CALLEGUAS MUNICIPAL WATER DISTRICT
Thousand Oaks, California

PROJECT NO. 450

FOR THE CONSTRUCTION OF THE
LVMWD-CMWD INTERCONNECTION

ADDENDUM NO. 2

Plate No. 23

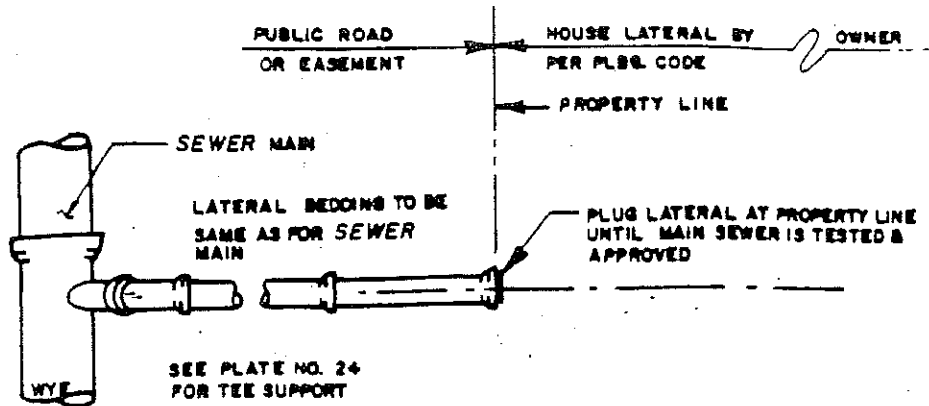
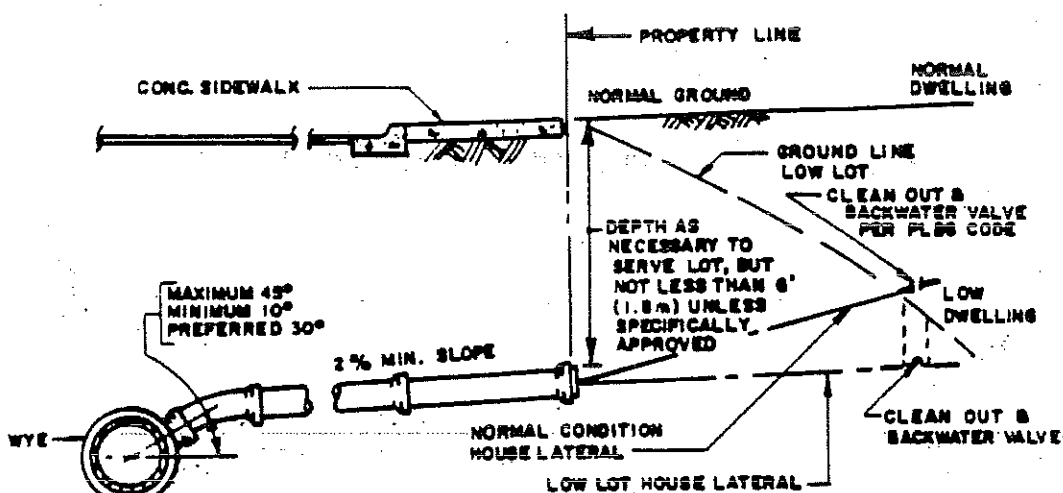
- Item AD2-43 INSERT the attached Exhibit G (Triunfo County Sanitation District Plate No. 23) into Appendix O – TWSD Plates, before Plate No. 25 Chimney.

- “CONNECTION TO EXISTING MAIN SHALL CONFORM TO TRIUNFO COUNTY SANITATION DISTRICT PLATE NO. 23. THE EXISTING SANITARY SEWER LINE IS 24 INCH DIAMETER VCP PER TRUNFIO COUNTY SANITATION DISTRICT’S RECORD DRAWINGS.”

DRAWING NO. C-13
JOB NO.
SHEET 19 OF 127

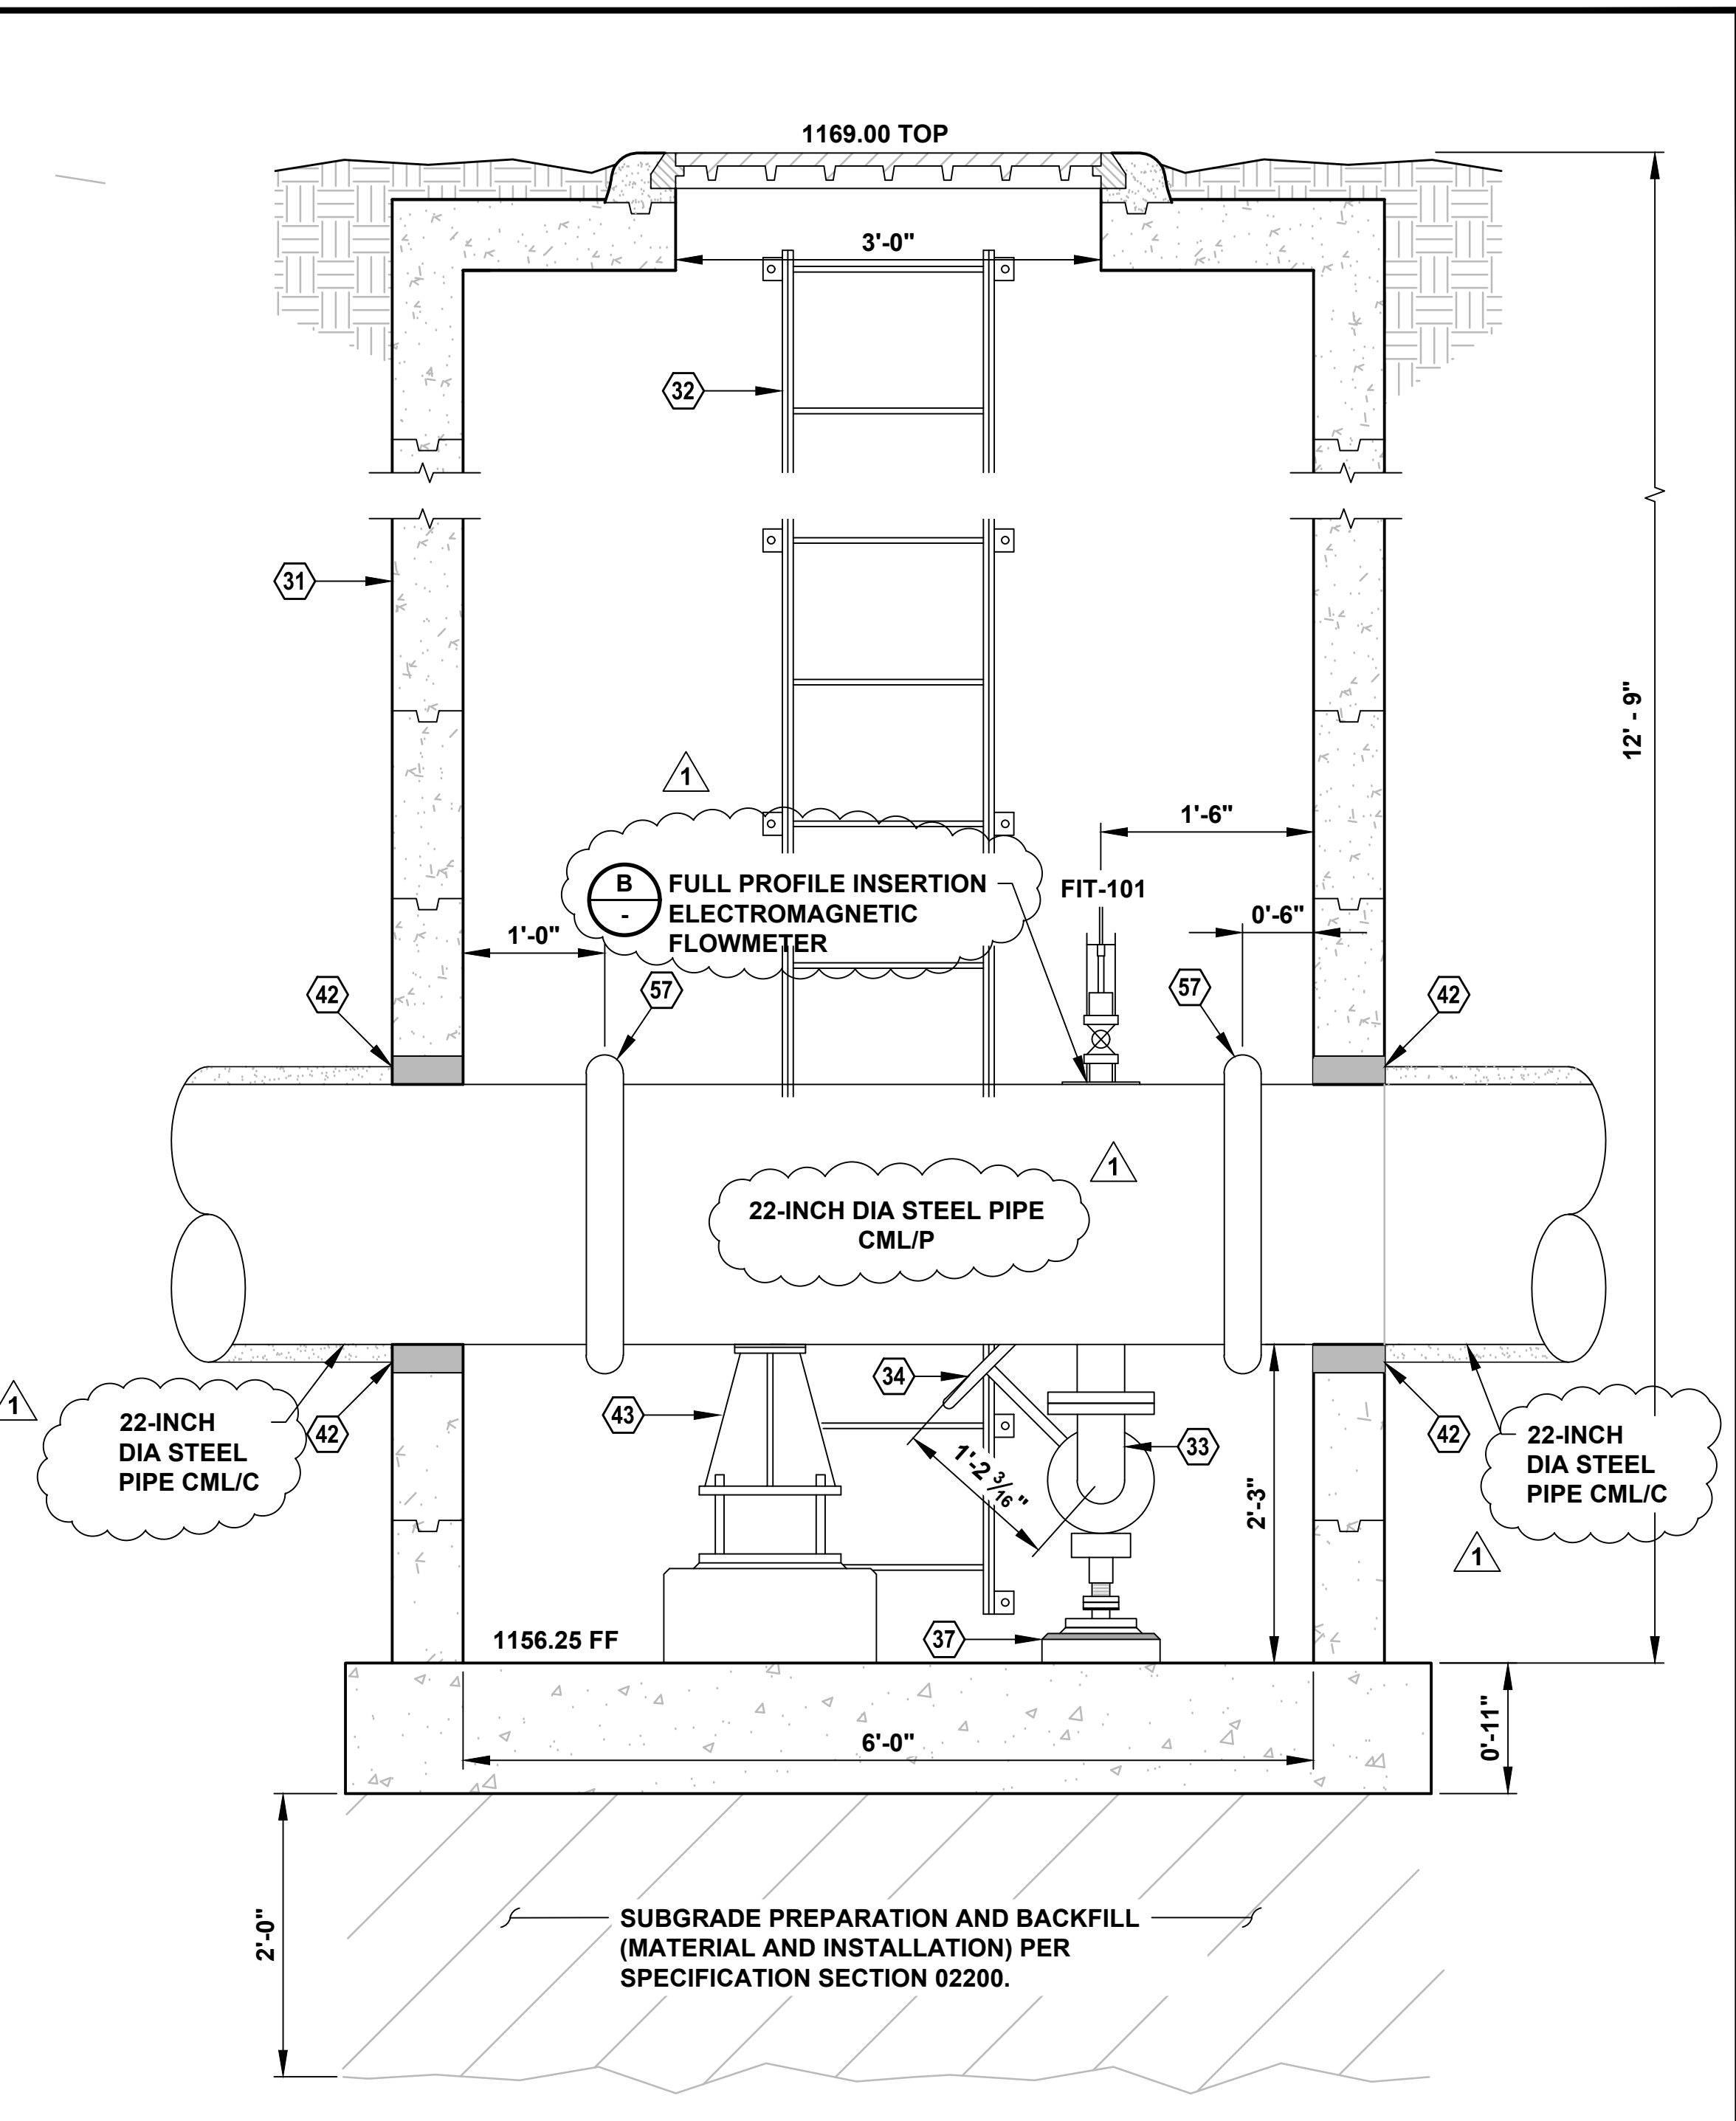
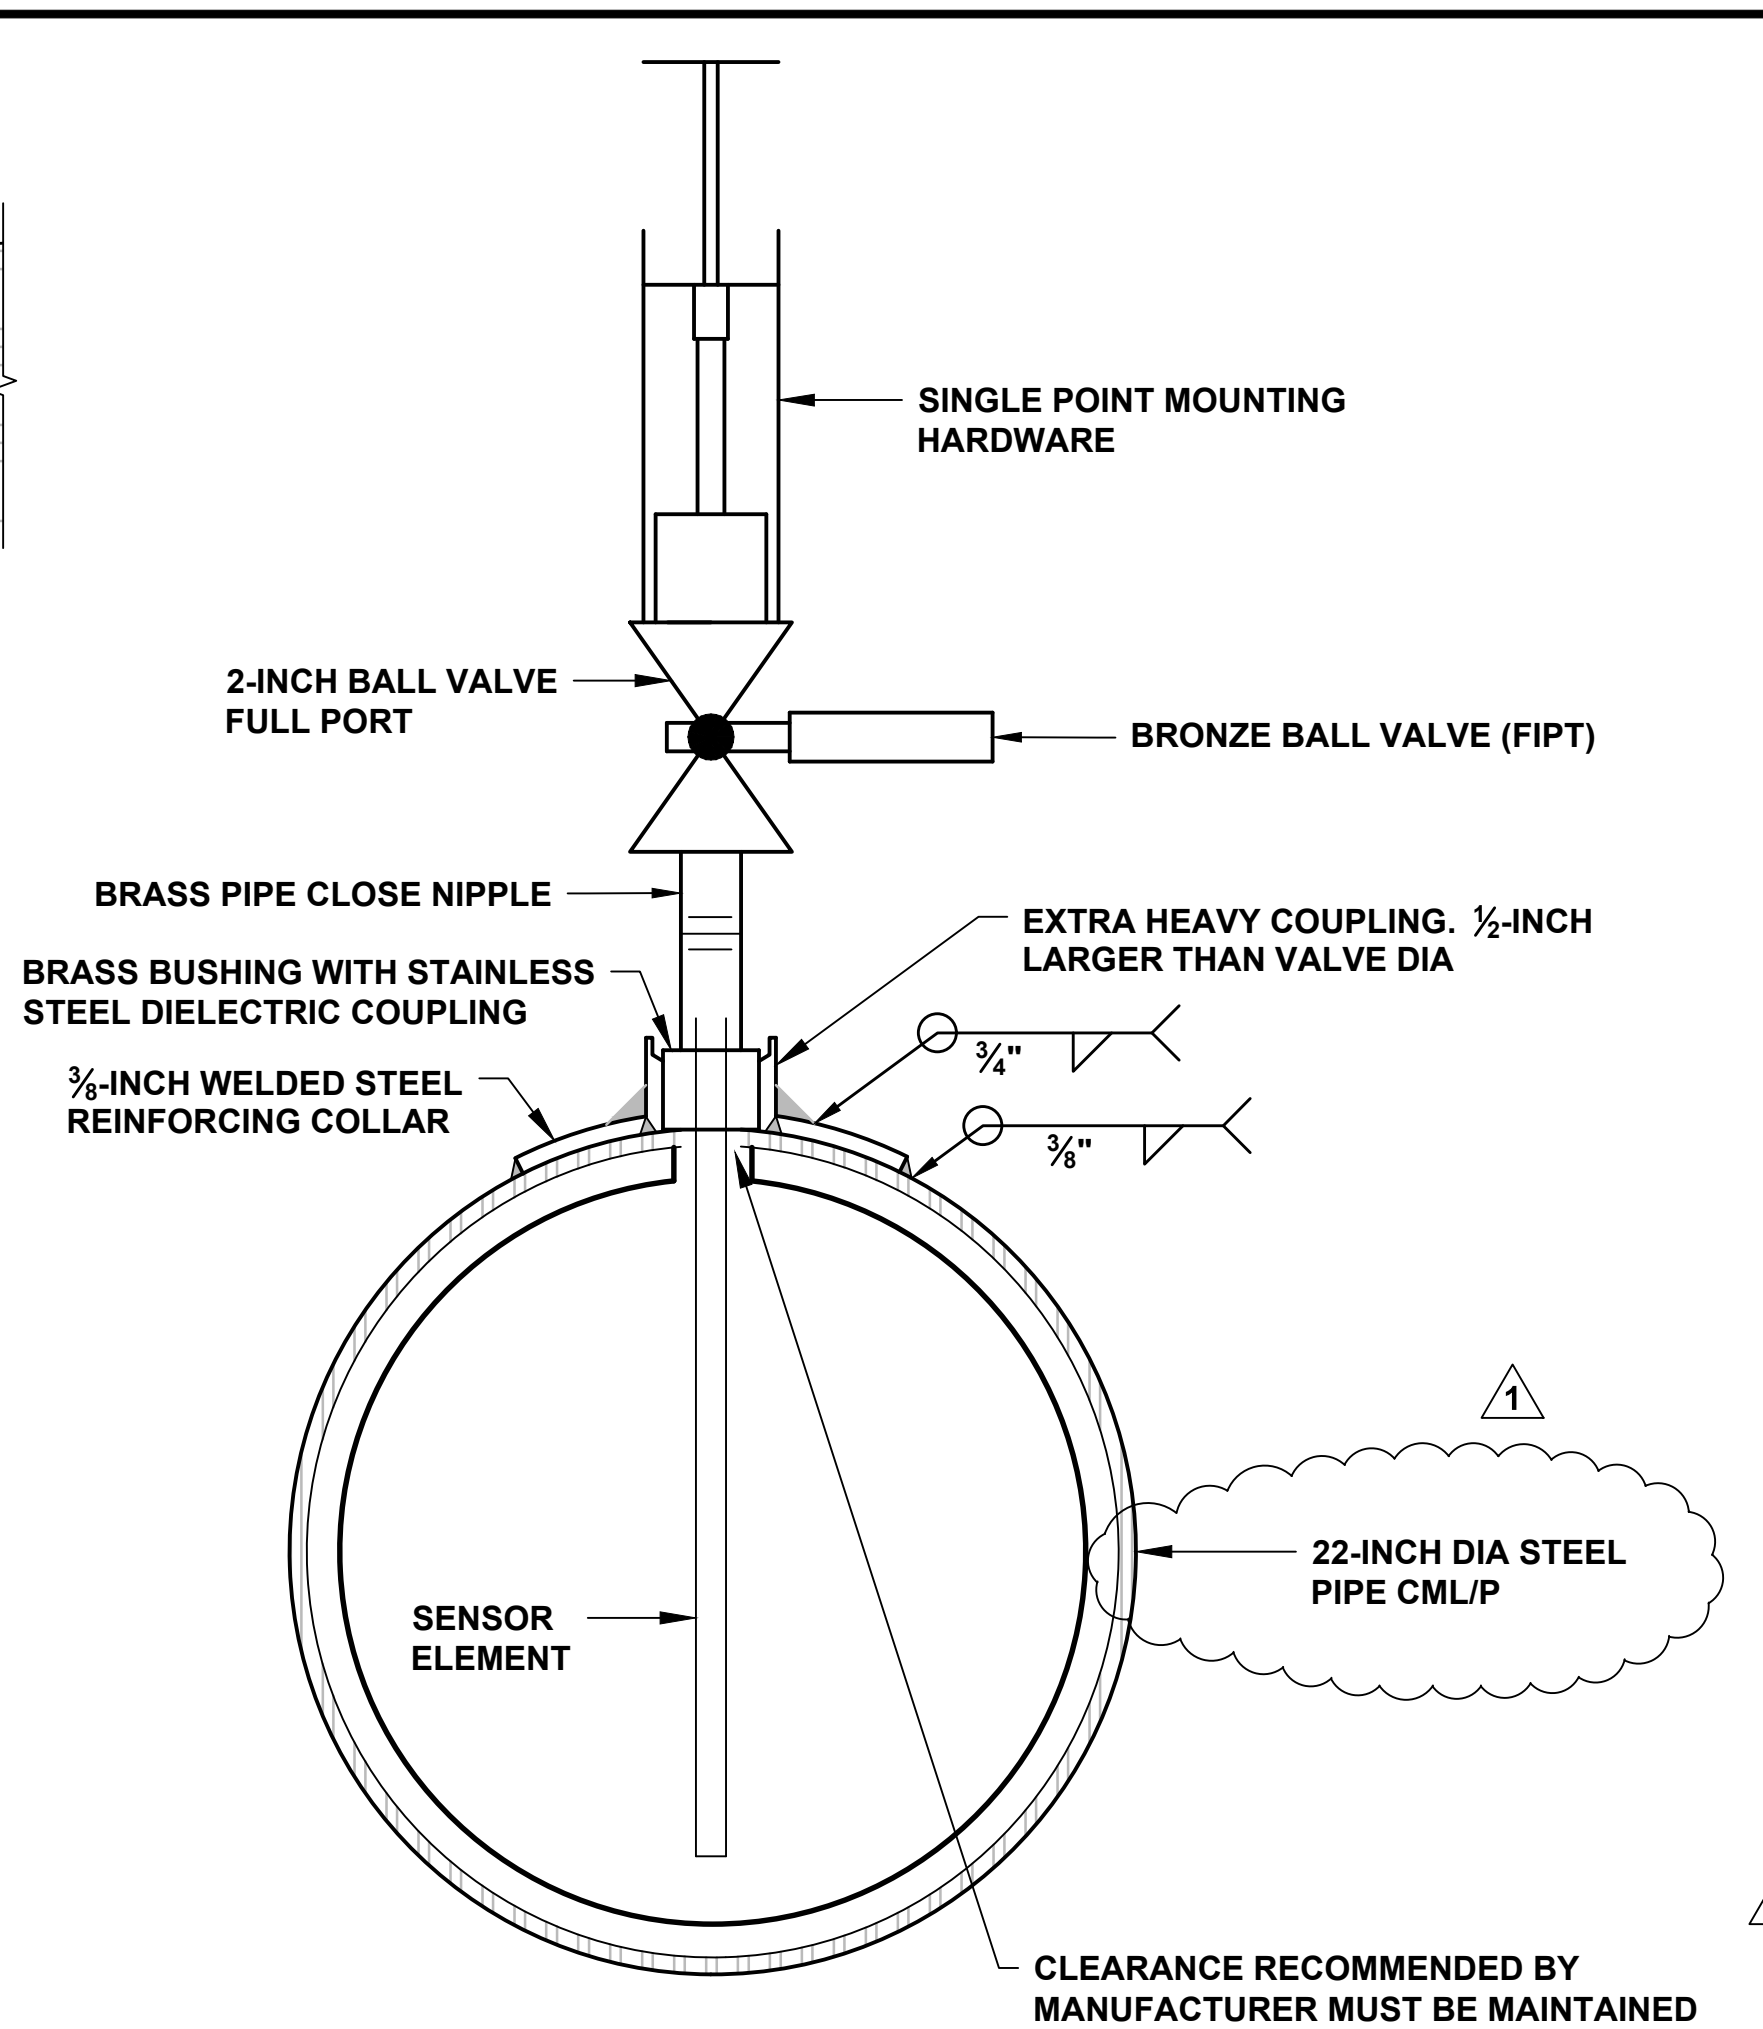
- Item AD2-48 DELETE all note callouts which state “4-INCH DIA” on Drawing C-12, Detail E, and replace with “1.5-INCH DIA.”
- Item AD2-49 REPLACE Drawing C-13 with the attached Exhibit H1, containing replacement Drawing C-13.
- Item AD2-50 REPLACE Drawing C-17 with the attached Exhibit H2, containing replacement Drawing C-17 and new Drawing C-17A.
- Item AD2-51 INSERT the following note at STA 2+69.82 on Drawing C-19:
